**STAFF REPORT**  
**COMMUNITY DEVELOPMENT DEPARTMENT**

DATE: 3/17/2026  
TO: City Council  
FROM: Sonya Allen, Associate Planner  
208-884-5533  
[sallen@meridiancity.org](mailto:sallen@meridiancity.org)  
SUBJECT: FP-2025-0021  
Burnside Ridge Estates No. 2

Final plat consisting of 36 buildable lots and 11 common lots on 12.57 acres of land in the R-4 zoning district for the second phase of Burnside Ridge Estates Subdivision.

A. Staff:

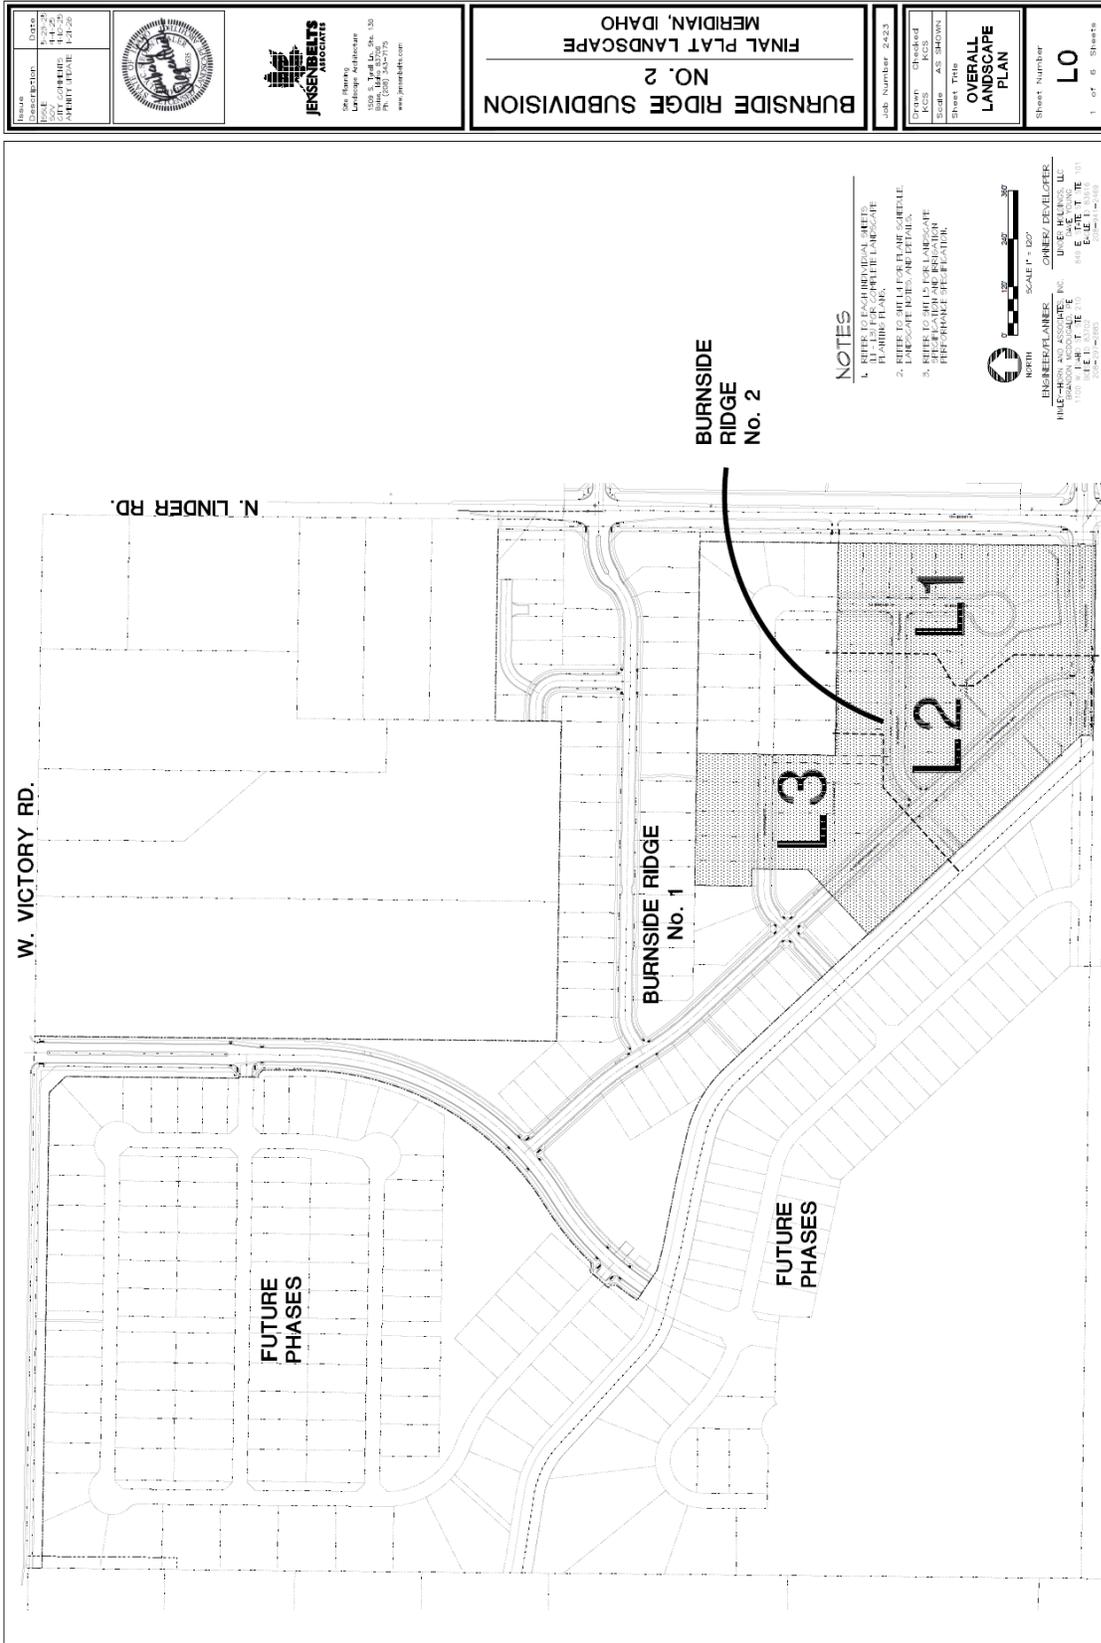
3. Prior to submittal for the City Engineer's signature, have the Certificate of Owners and the accompanying acknowledgement signed and notarized.
4. The final plat prepared by Clinton W. Hansen stamped on 2/6/26 by Clinton W. Hansen, included in Exhibit B shall be revised as follows:

- a. Note #10: Include the recorded instrument number of the development agreement (i.e. #2024-063338).
  - b. Note #12: Include the recorded instrument number of the ACHD temporary license agreement.

- c. Legend: Include the recorded instrument number of the ACHD permanent easement line.
  - d. Include the recorded instrument number of the ACHD temporary easement graphically depicted on Sheet 1.

- e. Include the recorded instrument number of the City of Meridian sewer easement graphically depicted on Sheet 1.
5. The landscape plan prepared by Jensen Belts Assoc., dated 1/21/26 included in Exhibit C, shall be revised as follows:

**OVERALL  
 LANDSCAPE  
 PLAN**

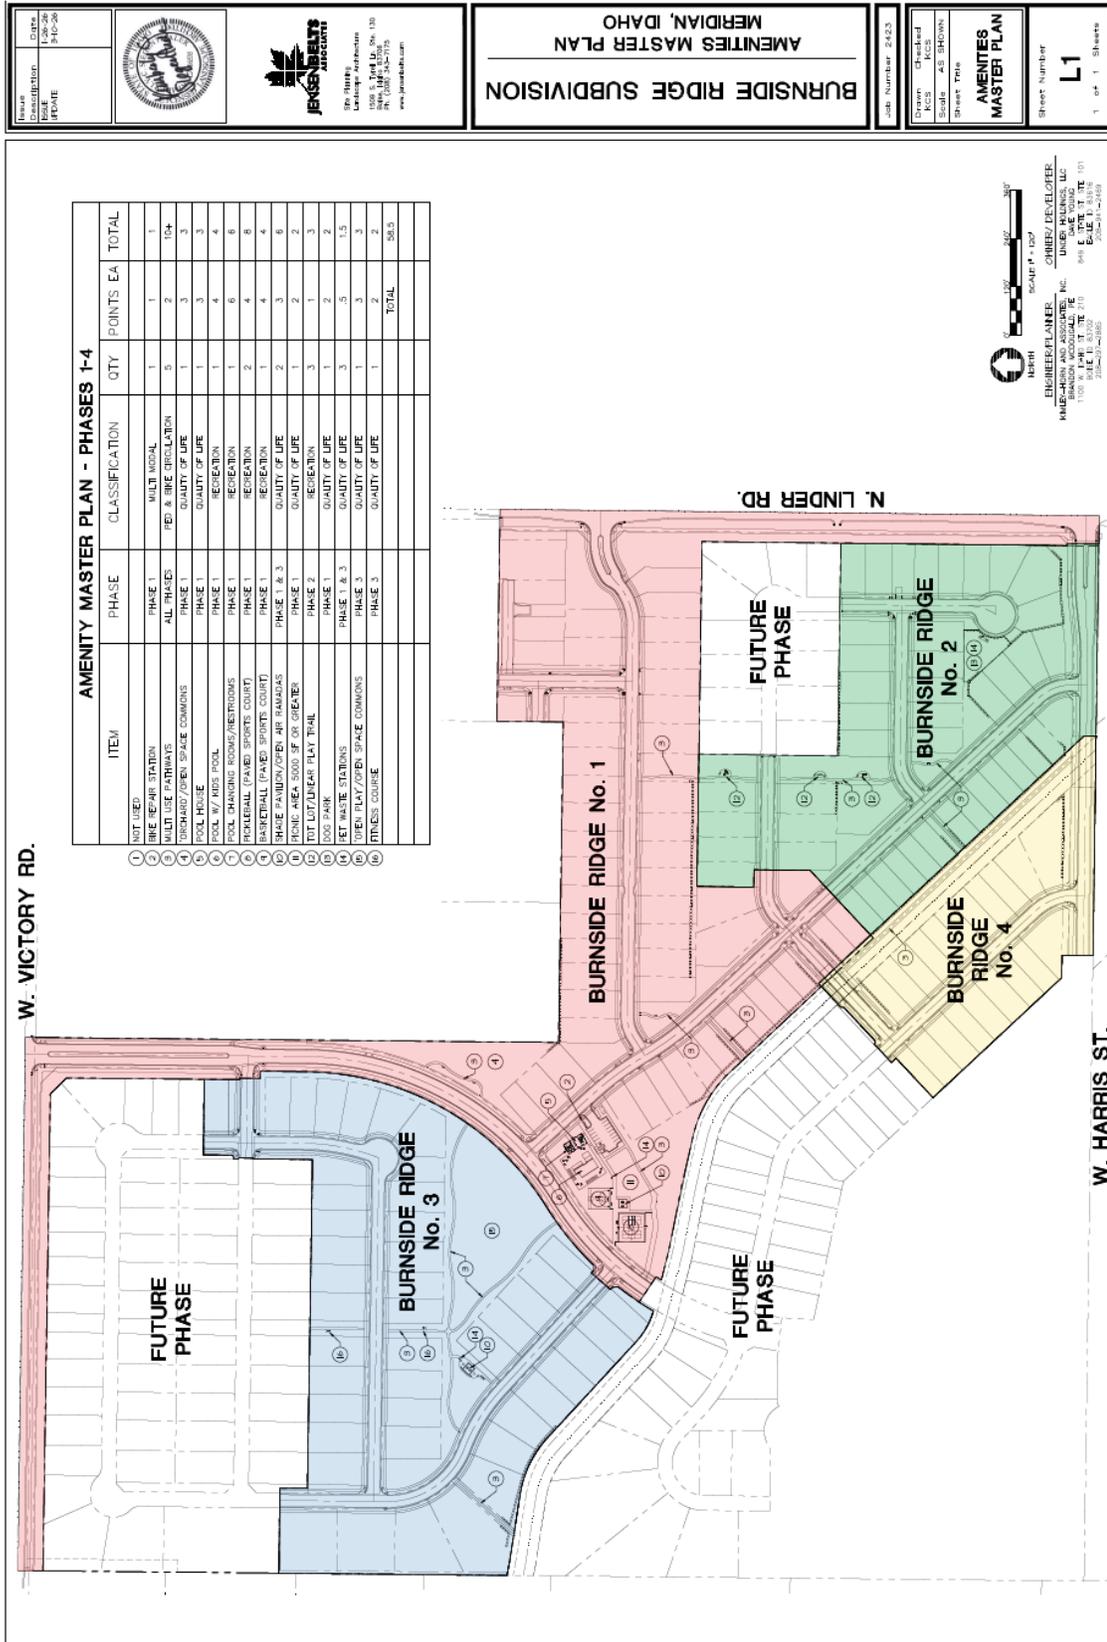
- a. Change E. Holstein Dr. to W. Harris St. consistent with the plat.
  - b. Depict landscaping with a mix of materials along each side of all pathways, in accord with the standards listed in UDC [11-3B-12C](#); include calculations that demonstrate compliance.

- c. Include the required vs. proposed number of trees in the calculations table that demonstrates compliance with the landscape standards for pathways in UDC 11-3B-12C, street buffers in 11-3B-7C and common open space areas in 11-3G-5B.3.

- d. The street buffer along the collector street (i.e. W. Harris St.) shall include enhanced landscaping as set forth in 11-3B-7C.3f with enhanced amenities with social interaction characteristics and enhanced context with the surroundings in accord with the standards listed in UDC 11-3G-3B.3. Identify the enhancements in a call-out.

- e. Include a detail of the children's play pods proposed on Lot 5, Block 4 and Lot 25, Block 3.
6. The dog park shall include the following in accord with UDC 11-3G-4C: bags for dog waste disposal, double entrance gate, benches and fencing to enclose the area. The dog waste station shall be an in the ground fixture with waste disposal bags and trash receptacle.
